Report in Opposition to Proposed Development by Capital Investment Group, Inc.

Report prepared by
Timothy G. Mara
Attorney at Law
1600 Scripps Center
312 Walnut Street
Cincinnati, Ohio 45202-4038
(513) 762-7674
Tmara4570@aol.com

September 17, 2018

Capital's Kenwood proposal dwarfs the adjacent homes to the west (left) and south (bottom)
Note: This drawing is a merger of the new site plan (C601) and Drawing A001 from Capital's original plans.

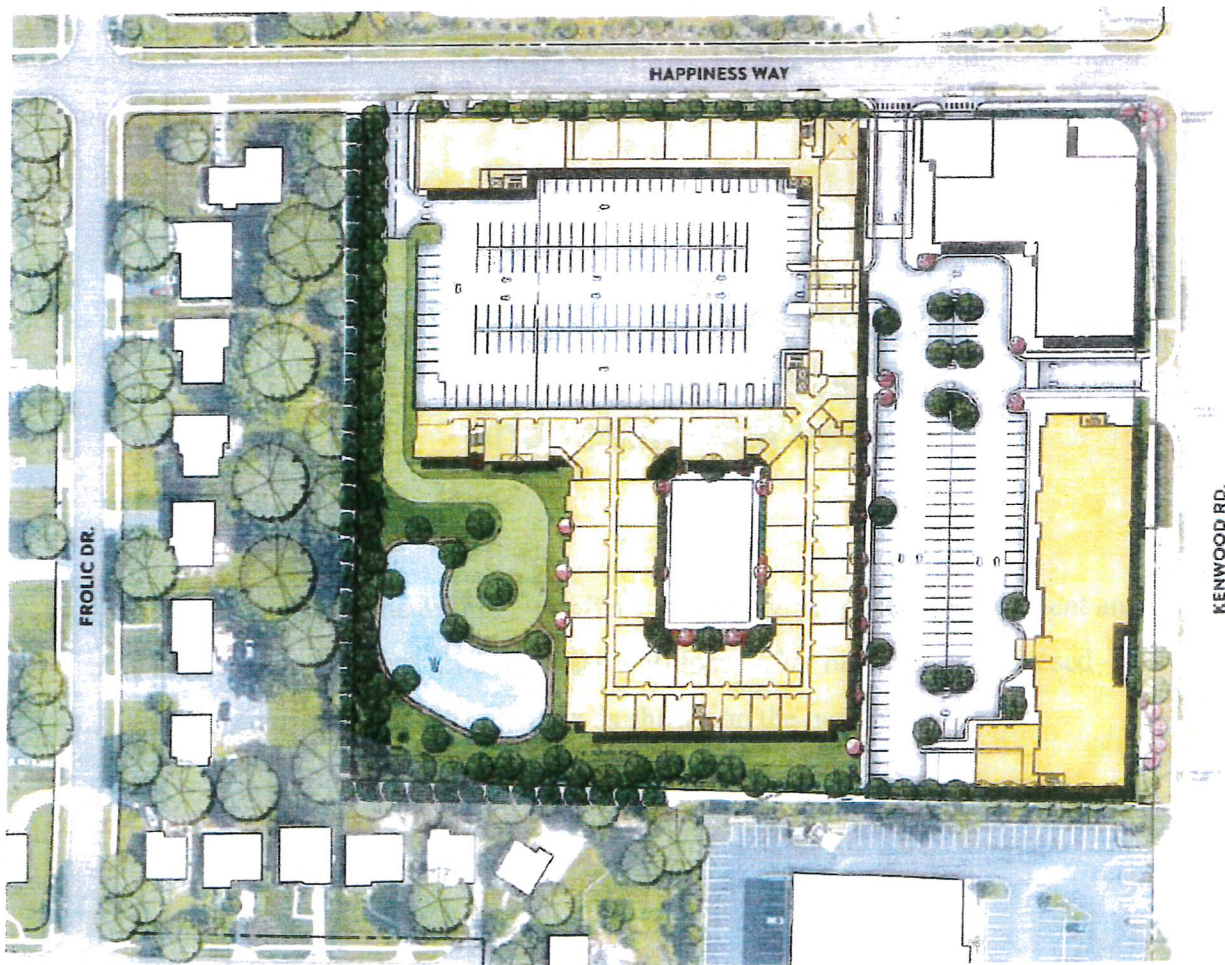
Capital’s proposed project is enormous, and completely out of scale with adjacent residences as shown on the photo and drawing on page 10.

Also, the abutting homes on Frolic Drive and Dunedin Avenue will be completely dwarfed by the proposed apartment buildings. The enjoyment of their backyards will be compromised because apartment dwellers will loom over them, some as close as 50 feet from their property lines.

Clearly, the scale of the proposed development is not compatible with adjacent residences.

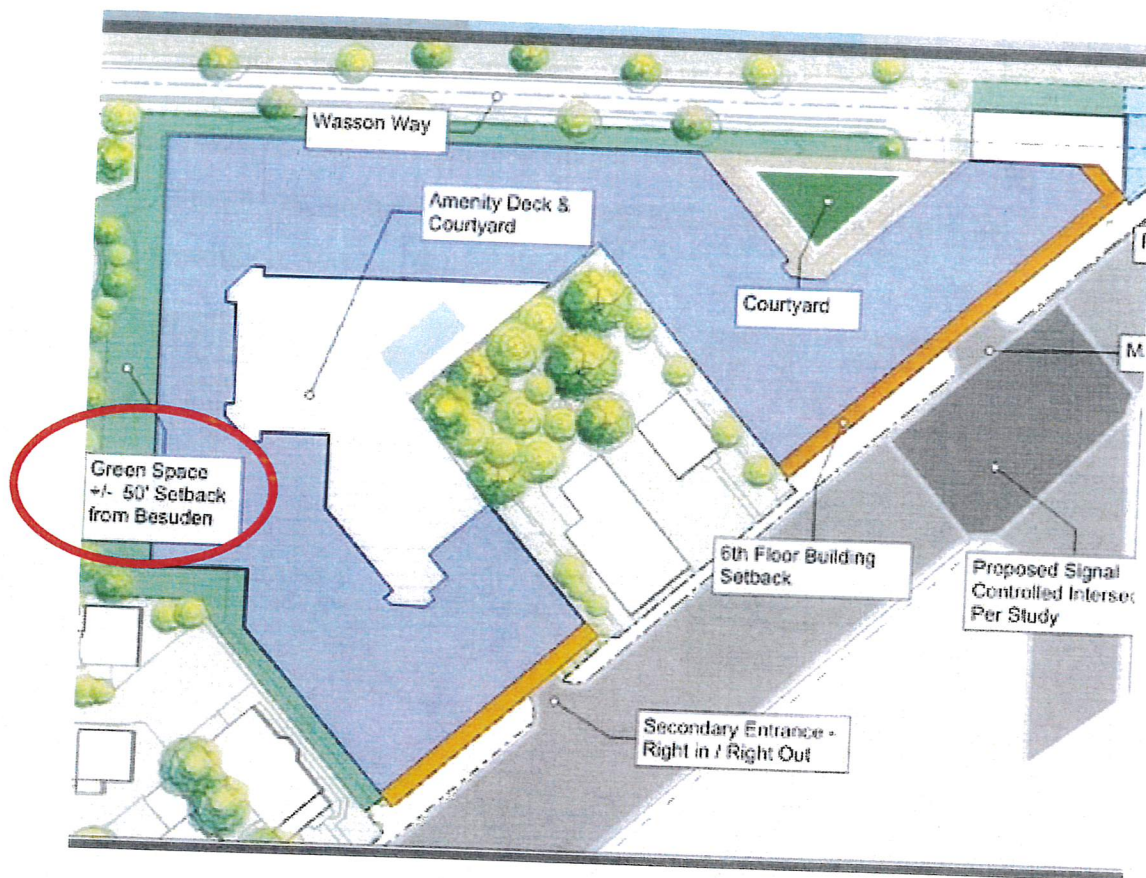
The western-most access drive is just under 20 feet from the western boundary of the site, and this is so narrow that an adequate landscaped buffer cannot be provided on the site itself. Capital's solution is to encroach upon neighboring properties to provide the balance of the landscaped buffer. Sec. 14-7 requires a boundary buffer of at least 20 feet, and Sec. 14-6.3 prohibits a driveway from crossing into the boundary buffer.

The word "driveway" is deceiving as applied to this route of access to the 897 space parking garage. The so-called driveway will in fact be a busy, private street. Good design, if applied, would provide a buffer yard which exceeds the 20' minimum in order to truly buffer adjacent homes from this very intense development.

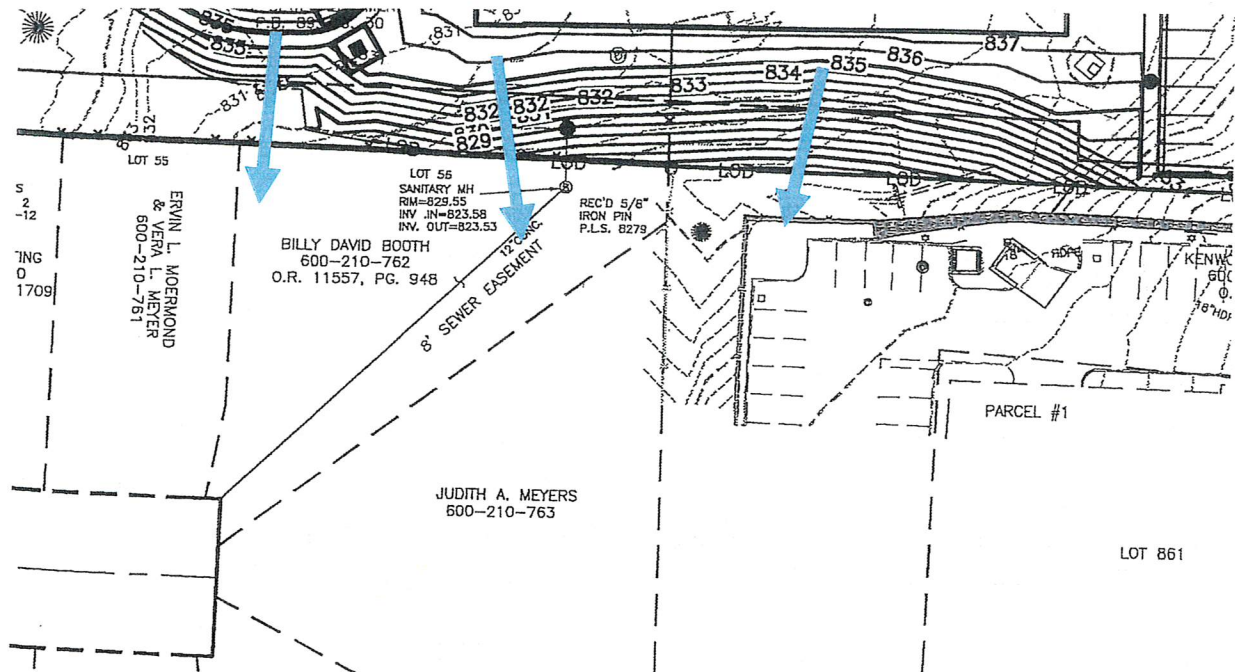
Currently, there are more than seventy (70) mature trees on the site.⁵ Many of them appear to be at least 60 feet in height (see Google Earth photo below). Replacing 70 magnificent trees, many of them oak, with a mix of small trees and bushes doesn't meet the expectations of the Zoning Resolution.

As best as can be determined from the site plan, only one of those trees will be saved and incorporated into the new site plan. Capital should get an “F” for its noncompliance with Sec. 8-1.3(F) of the Zoning Resolution.

This base map is an excerpt from Drawing C300 submitted by the applicant, with the blue arrows added to show the direction of stormwater flow

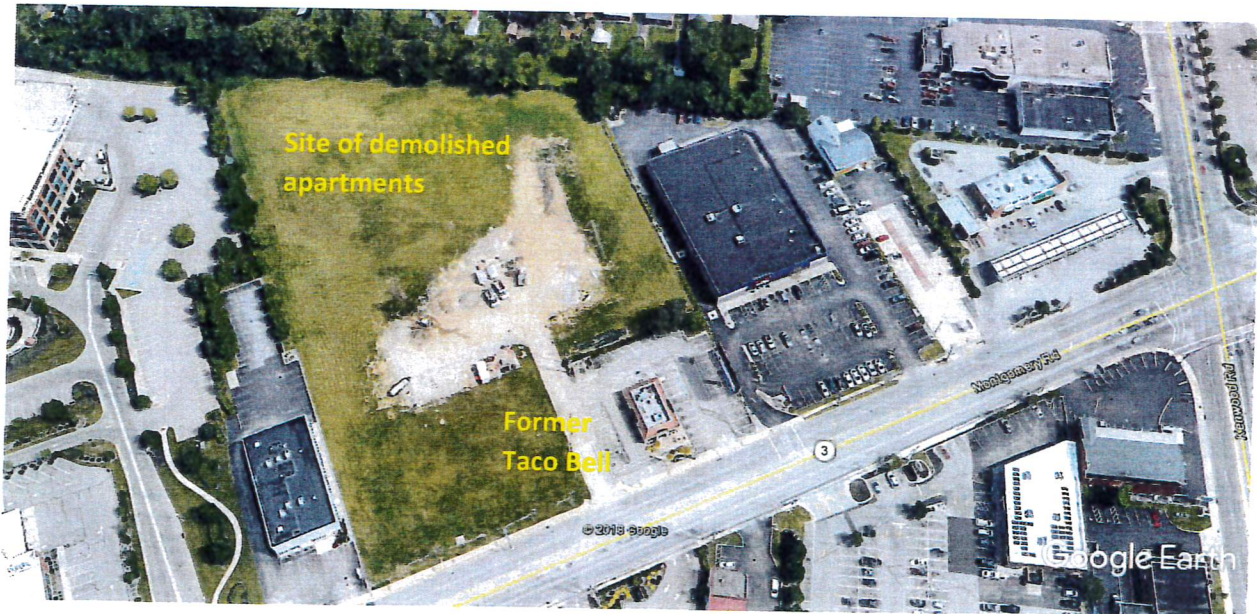
The Land Use Plan provides that “Drainage shall be designed and constructed so as to not detrimentally affect adjacent properties.”⁶ However, Capital’s proposal calls for creation of a long embankment along the southern boundary of the site that will make the site about 10 feet higher than the backyards of adjacent homes on Duneden Avenue.

That means that stormwater from the embankment will flow down the embankment and pond in those backyards unless provisions are made to direct that water into public sewers if available. Without such an effort, the enjoyment of back yards on Duneden will be impacted.
